ADDENDUM NO. 2

METROPOLITAN SEWERAGE DISTRICT MSD ITT PUMP STATION REPLACEMENT

MSD PROJECT NO.: 2020061
MCKIM & CREED PROJECT NO.: 09596-0001

ADDENDUM ISSUE DATE: JULY 16, 2026

FORCE MAIN PLAN AND PROFILE
STA. 20+00 - STA. 26+48

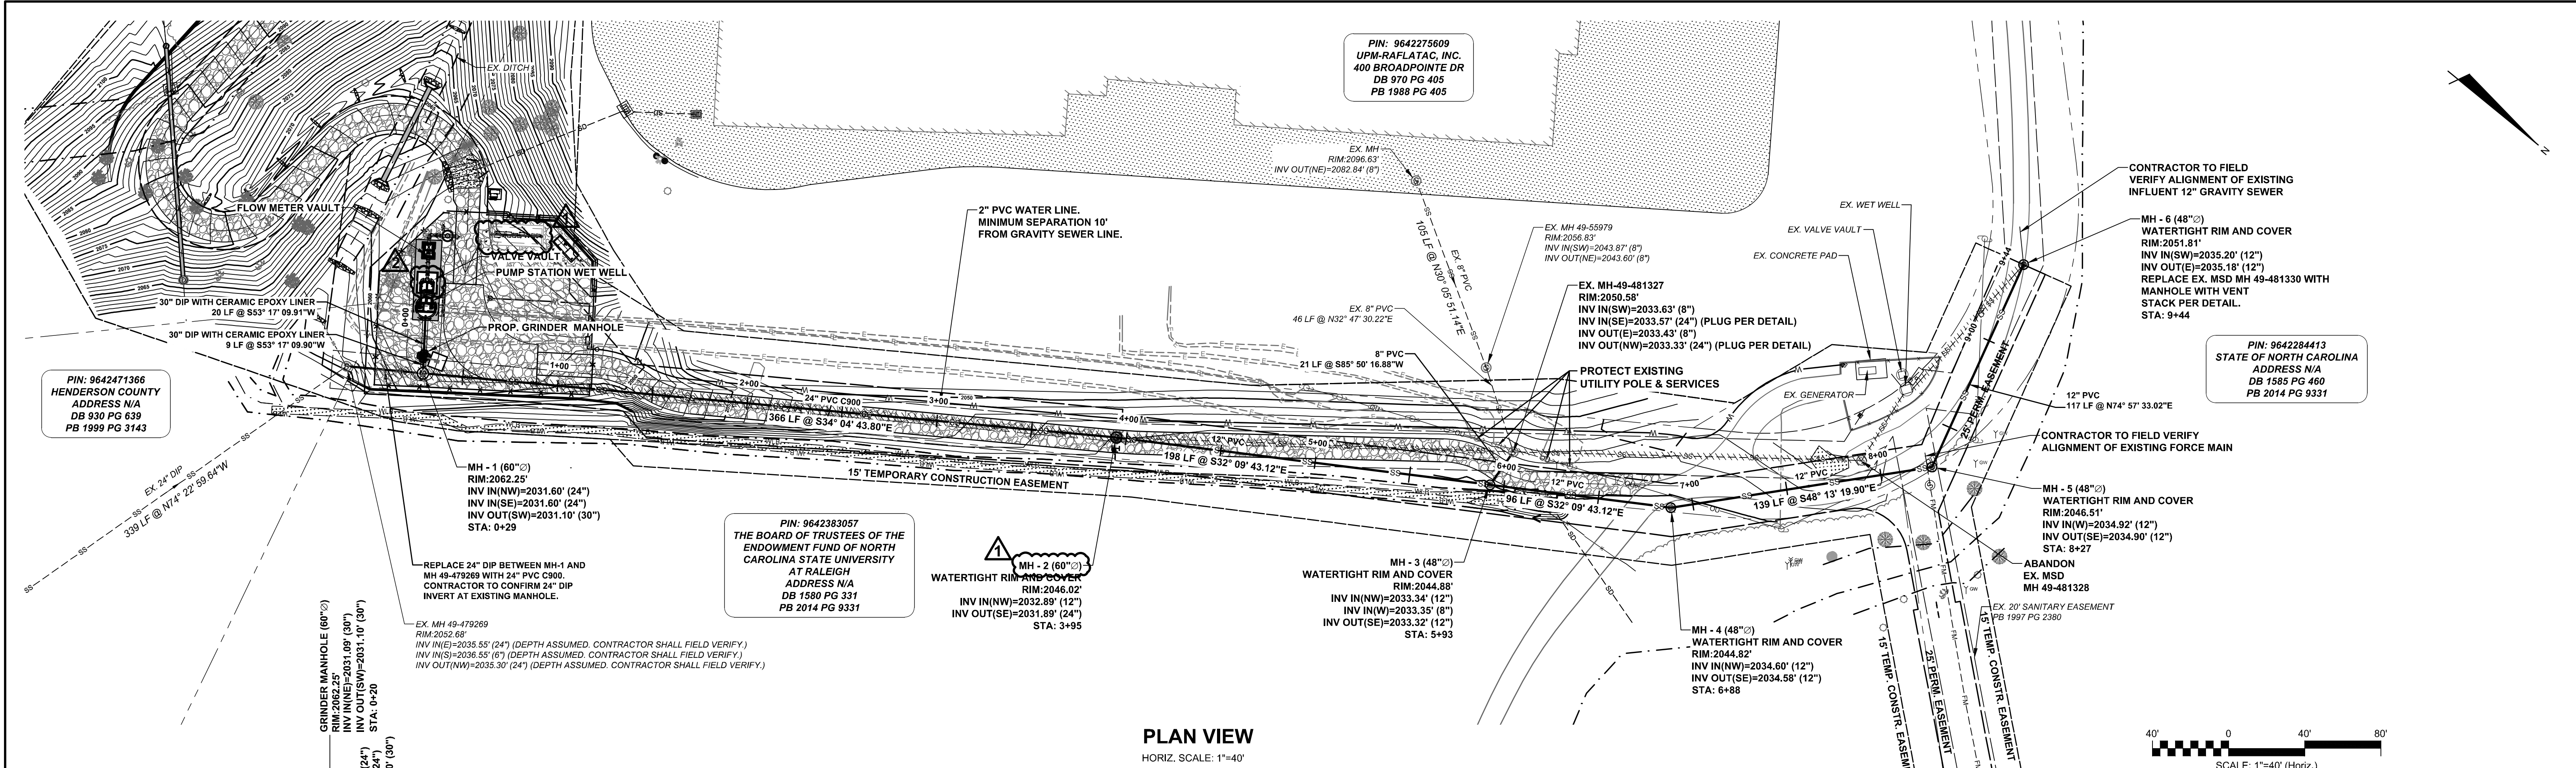
26. QUESTION: Confirm all pipe is DIP through the 16" MJ 45 after ARV 1.

RESPONSE: The force main pipe shall be HDPE DIPS DR-11. Revised sheets CU04.1 – CU04.3 are attached to this Addendum No. 2.

GRAVITY SEWER PROFILE VIEW
HORIZ. SCALE: 1"=40'
VERT. SCALE: 1"=4'

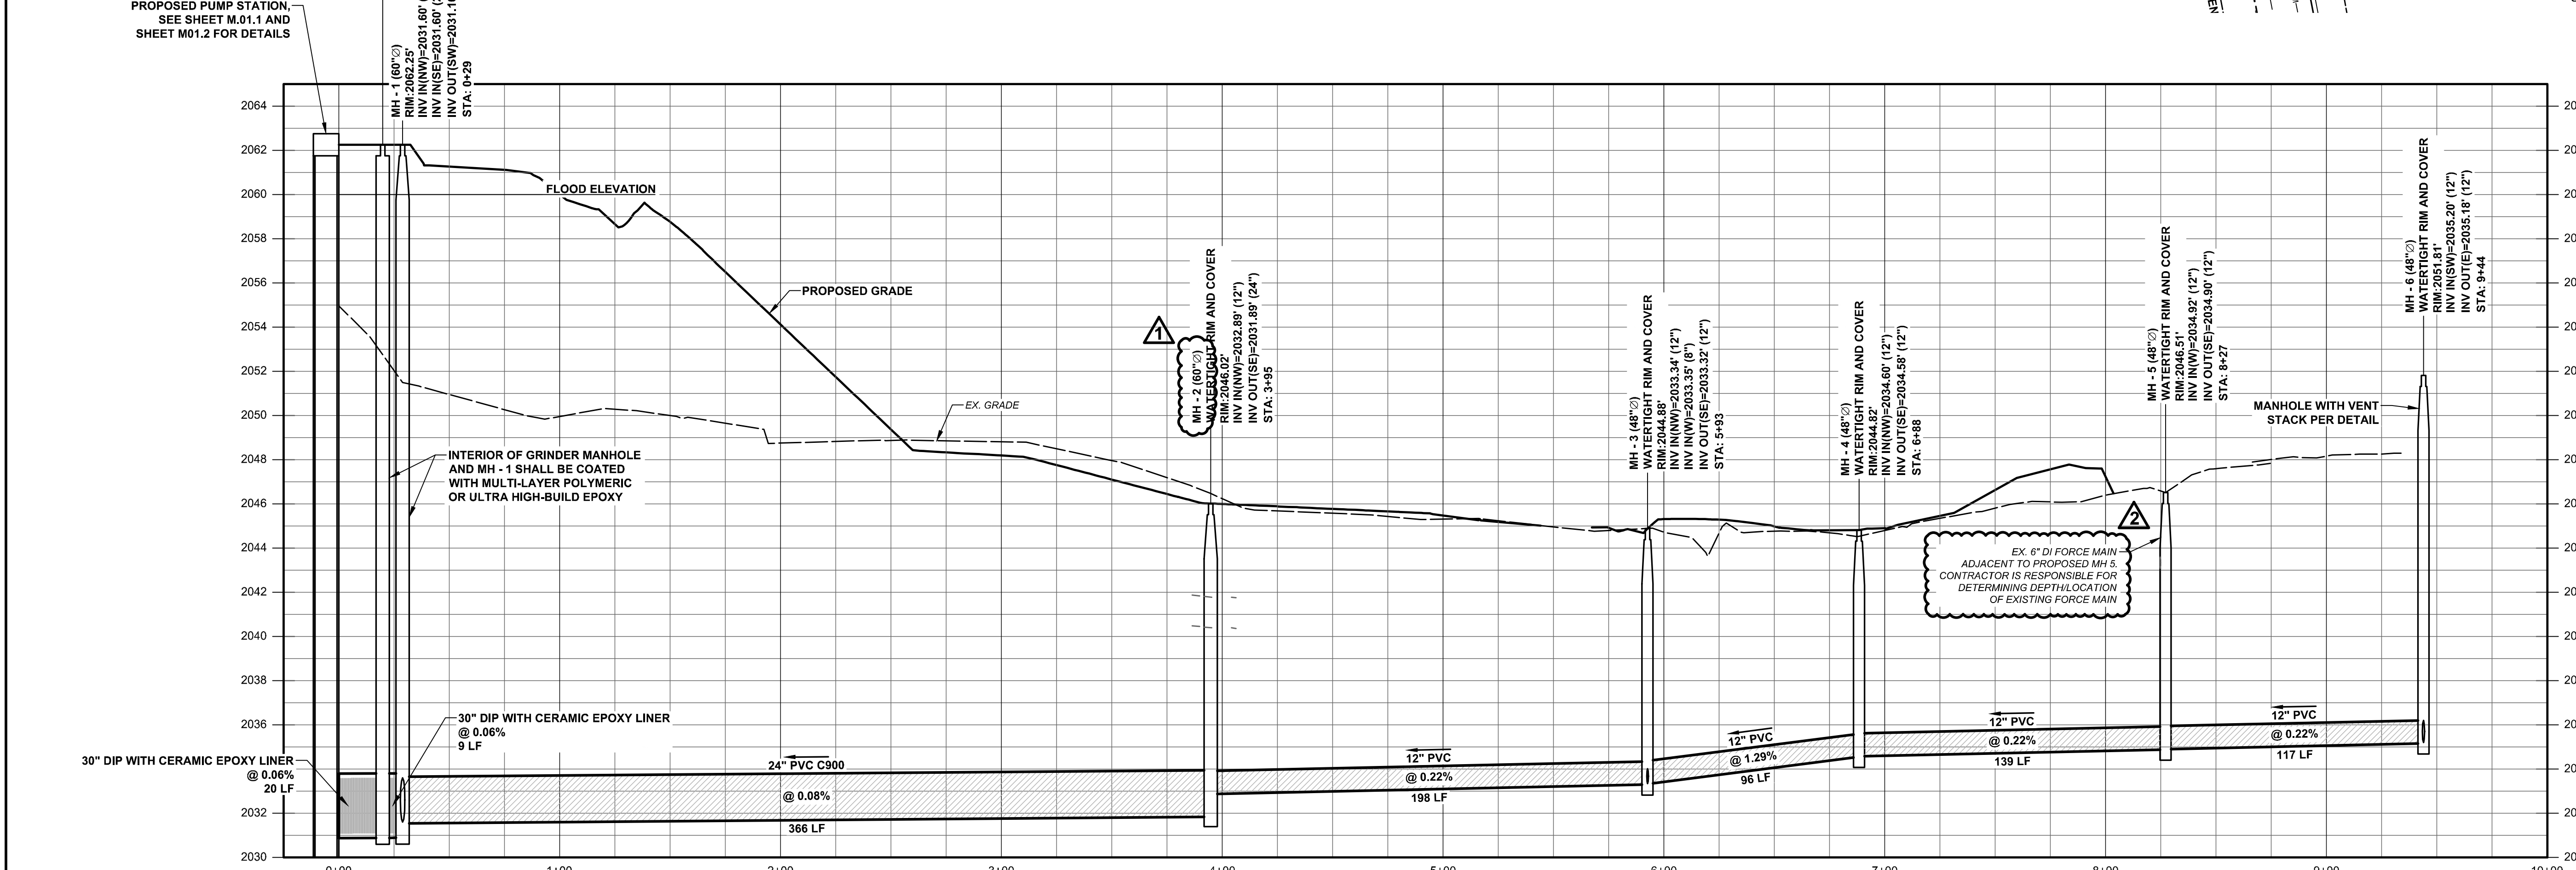
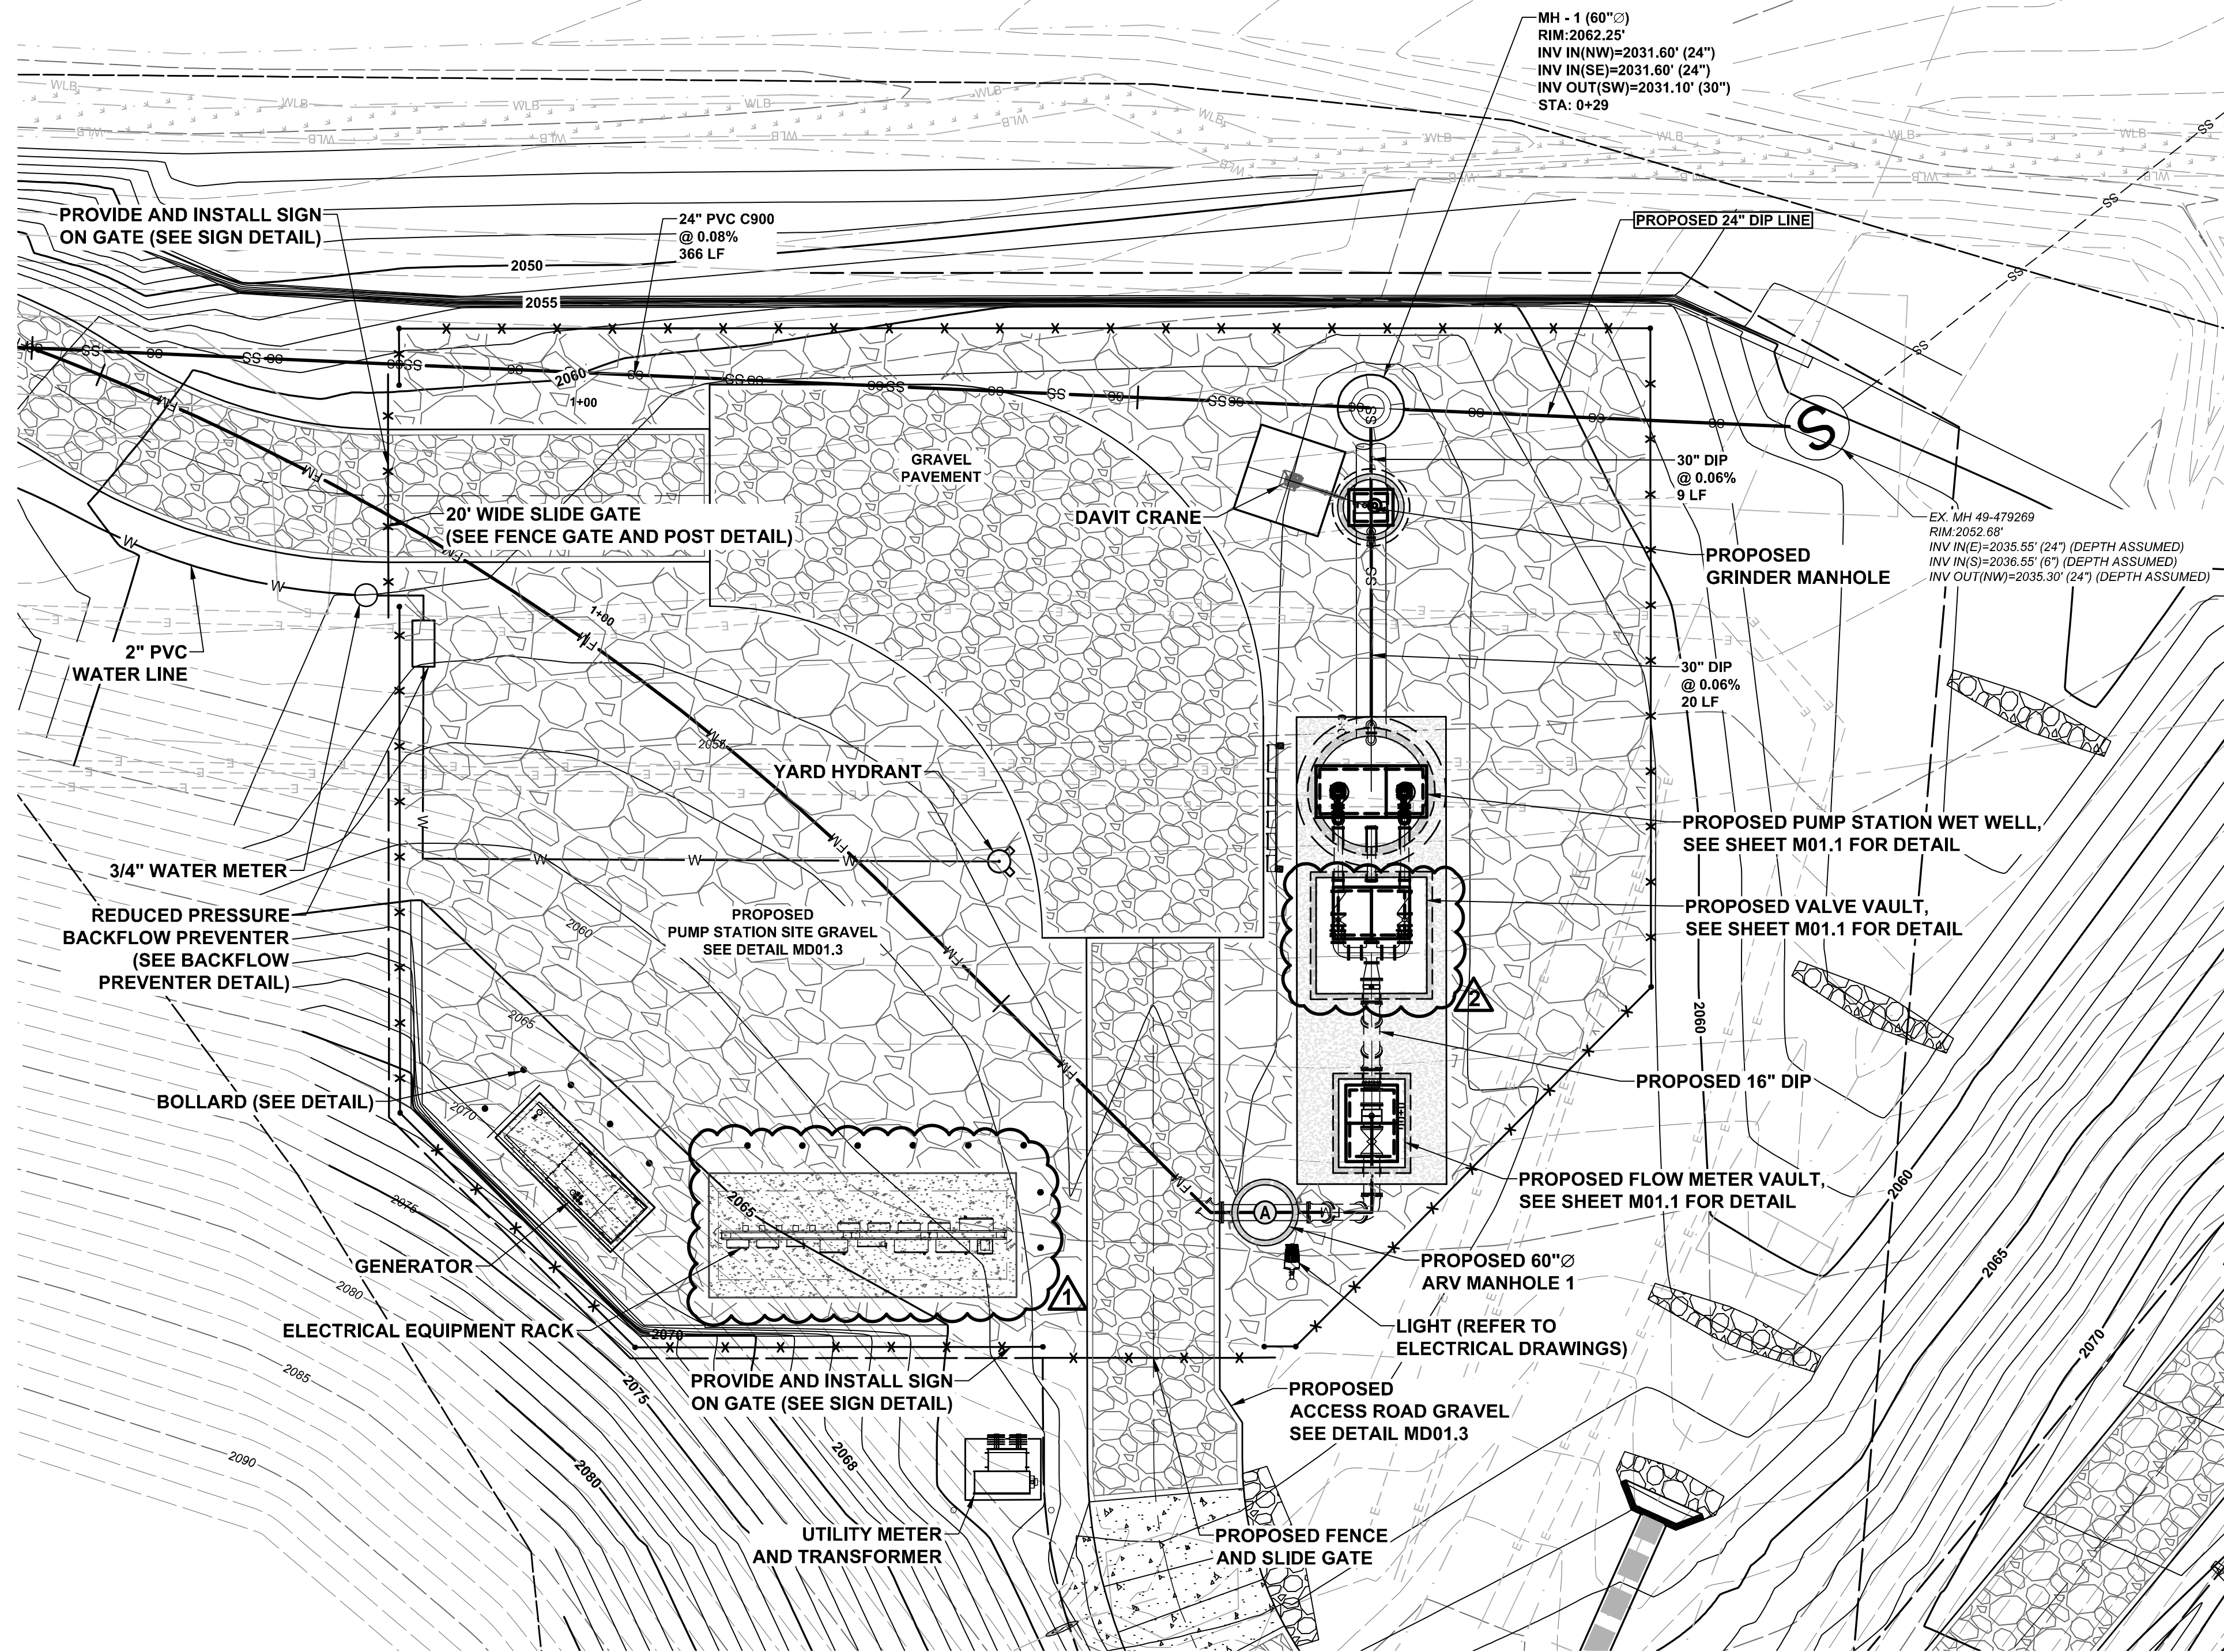
27. QUESTION: What do the dotted lines depict on the profile on Sheet CU05.1 from STA 4+00 to 8+00?

RESPONSE: The dotted lines depict the existing 24" gravity sewer, which will be abandoned in place. It is removed from CU05.1 attached to this Addendum No. 2.
